State of Oregon Department of Environmental Quality

Oregon Environmental Quality Commission Meeting

Item C: Rulemaking (Action)

2018 – 2028 Regional Haze State Implementation Plan

Figure 3-5. EJ "score" of facilities where controls are likely to be required.

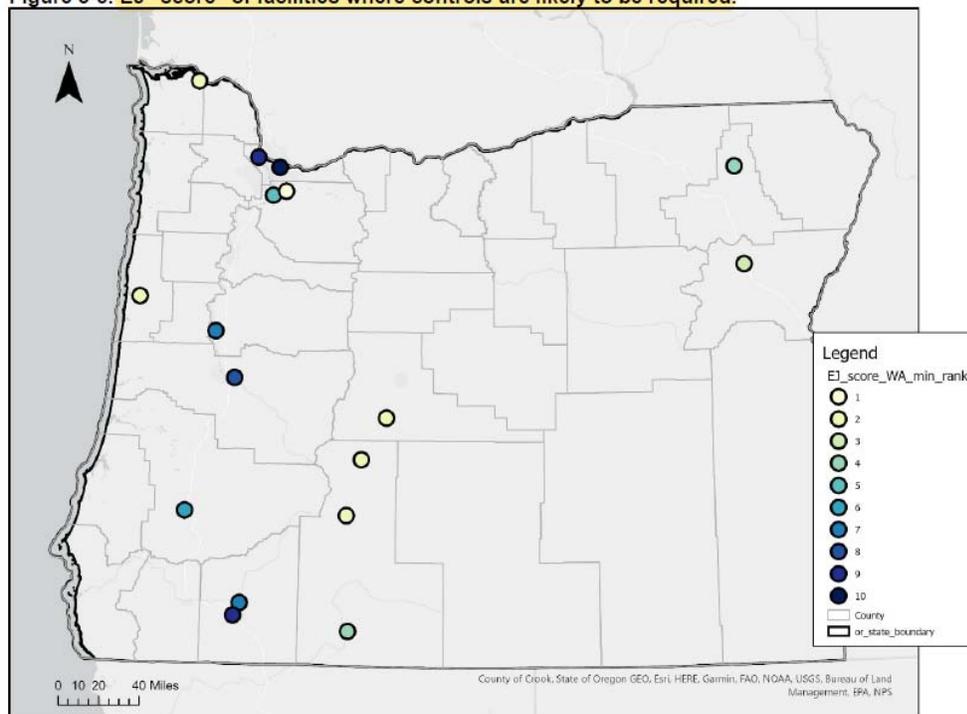
Although Oregon's Regional Haze rules require DEQ to take environmental justice into account when selecting emissions controls for sources, DEQ offered the state's largest polluters an exit plan from the requirement to install emissions controls seemingly without any consideration for Oregon's environmental justice communities—the very communities bearing the brunt of pollution. DEQ defines environmental justice as requiring “the fair and meaningful involvement” of affected communities. See SIP 39. And yet, DEQ decided to off-ramp major polluters in overburdened communities without any consultation with those communities. DEQ's actions in extending “alternative compliance” are wholly at odds with its claim that “DEQ believes that emission reductions in Oregon should be targeted towards those communities that experience the greatest burden.” SIP at 38.

Despite the claim in the SIP that DEQ incorporated environmental justice into its regional haze decisions, nothing in the SIP suggests that DEQ considered environmental justice in making the choice to extend “alternative compliance” to 16 of the 17 facilities with reasonable progress controls. While DEQ carefully established a protocol and analyzed the environmental justice and vulnerable populations “score” of each facility with cost-effective controls identified in its four-factor analysis, it then seemingly ignored this information when making consequential decisions: in place of actual significant reductions in emissions that would be achieved through the implementation of four factor reasonable progress control analyses the agency instead established alternative compliance to these facilities regardless of the environmental justice impacts and the impacts on vulnerable populations.

See Off-Ramped Facilities, Regional Haze Map, <https://tinyurl.com/2zmcsfwuc>.

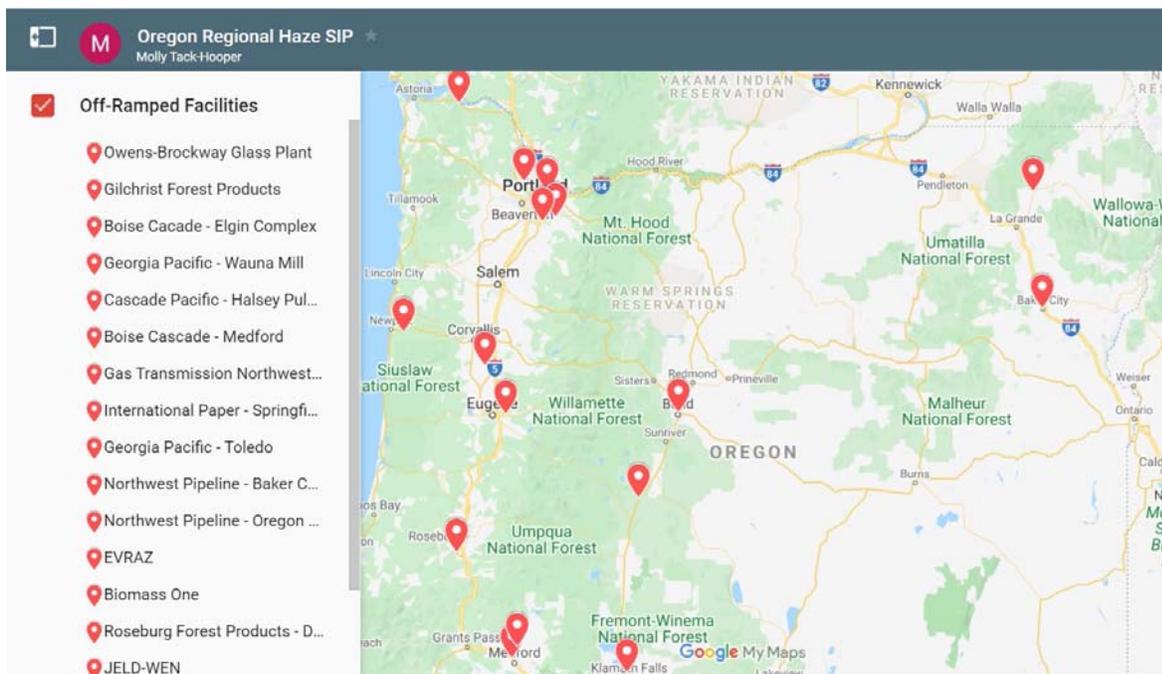
DEQ's backroom agreement with Owens-Brockway underscores the environmental justice costs of allowing some of the state's largest polluters to off-ramp from the Regional Haze Program without requiring actual emission reductions equivalent to what could have been achieved from requiring the facility to install reasonable progress controls.
